Technical Justification
for the Risk Informed
Modification to Selected
Required Action End
States for CEOG
Member PWRs

CE NPSD-1186-A, Rev 00

SUBJECT: SAFETY EVALUATION OF CE NPSD-1186, REV. 00, "TECHNICAL JUSTIFICATION FOR THE RISK INFORMED MODIFICATION TO SELECTED REQUIRED ACTION END STATES FOR CEOG MEMBER PWRs" TAC NO. MA8858

Figure 1. Potential Outage Paths

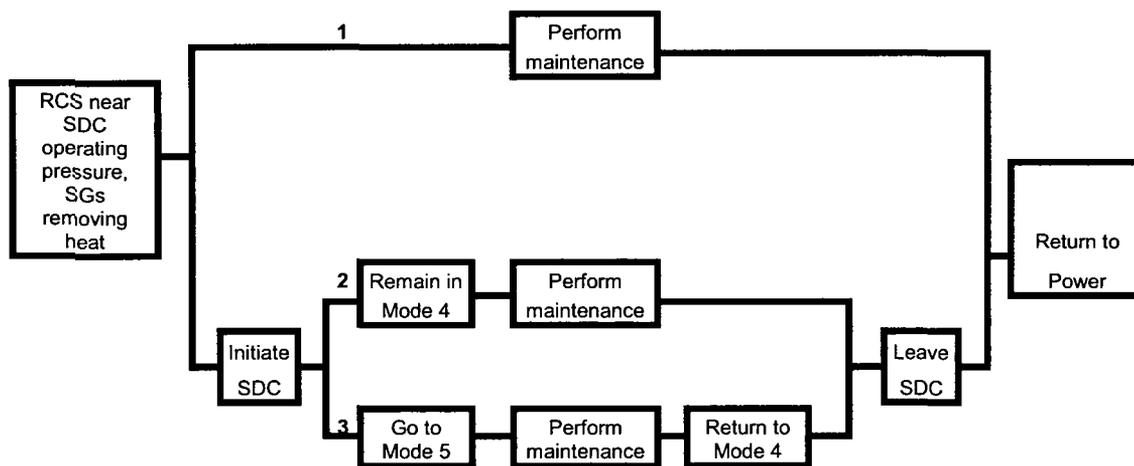
To assess the Reference 6 request and conclusions, the staff first considered the generalized outage path illustrated in Figure 1 that starts with the plant in Mode 4, with decay heat removed by SGs, and with RCS pressure relatively close to SDC operating conditions.

In Path 1, conditions are normally such that SDC can be initiated if needed. In Paths 2 and 3, there is a high likelihood that (1) SG cooling can be initiated if there is a loss of SDC, and (2) plant conditions will continue to support this capability. This means, for example, that there is no breaching of the RCS pressure boundary and at least one train of auxiliary feedwater (AFW) is available. TS specify the minimum allowable makeup/emergency core cooling system (ECCS) capability during Mode 4, and voluntary actions, 10 CFR 50.65(a)(4), and commitments address this capability during Modes 4 and 5. The result of these combinations is that the overall risk associated with the "Perform maintenance" box should be similar for many maintenance operations, regardless of path, although there are perturbations as discussed in the next paragraph.

Path 1 is generally preferred over path 2 and path 2 is preferred over path 3. There are no transitions, and in many cases no delays, prior to performing maintenance in Path 1. Paths 2 and 3 require additional steps to initiate SDC as well as to leave SDC, steps that typically extend shutdown time by 8 to 16 hours (Reference 6). There are some short-term transitional risks as well. Selection of Path 3 means an additional transition from Mode 4 to Mode 5 in which the plant is placed in an increased cooldown rate condition to "step" quickly across the Mode 4/Mode 5 "boundary" to avoid an inadvertent re-entry into Mode 4. Path 3 also introduces potential conditions where an operator may cause a TS violation if he allows the plant to move from Mode 5 to Mode 4 while addressing problems with SDC. Finally, additional actions are necessary to move from Mode 5 to Mode 4 following completion of maintenance, with associated delays. Consequently, Path 1 will generally take the shortest time and may expose the plant to the lowest risk provided all other plant conditions are the same. Similarly, Path 2 will generally be preferred over Path 3 if Path 1 cannot be followed.
